**Subject** ► Changes on Side Handles

**For Models** ► HM1200K, HM1200B, HM1211B and HM1200(Demolition Hammers)

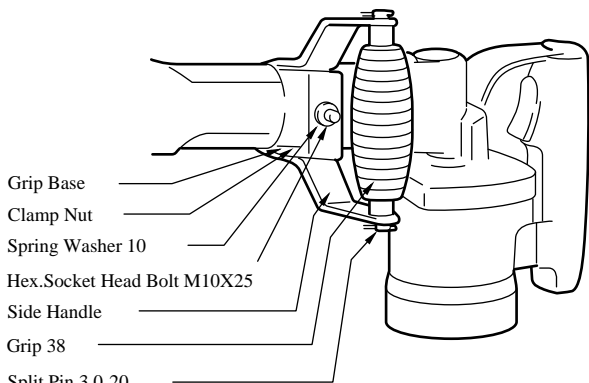
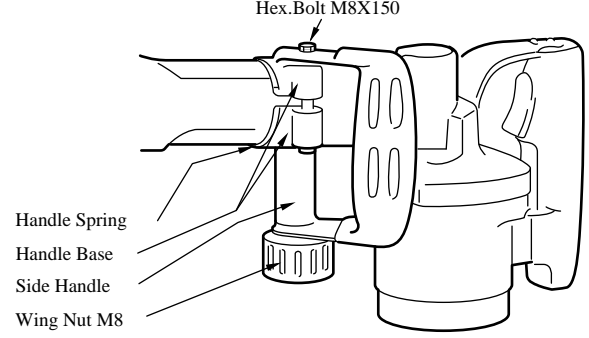
► Current	► New
 <p>Hex. Wrench 8 is necessary to loosen/tighten Hex. Socket Head Bolt for adjustment of the grip position.</p>	 <p>The Side Handle can be swivelled by loosening Wing Nut M8 and can be fixed in suitable position by tightening it. And Hex. Wrench 8 is now unnecessary and removed from standard equipment.</p>
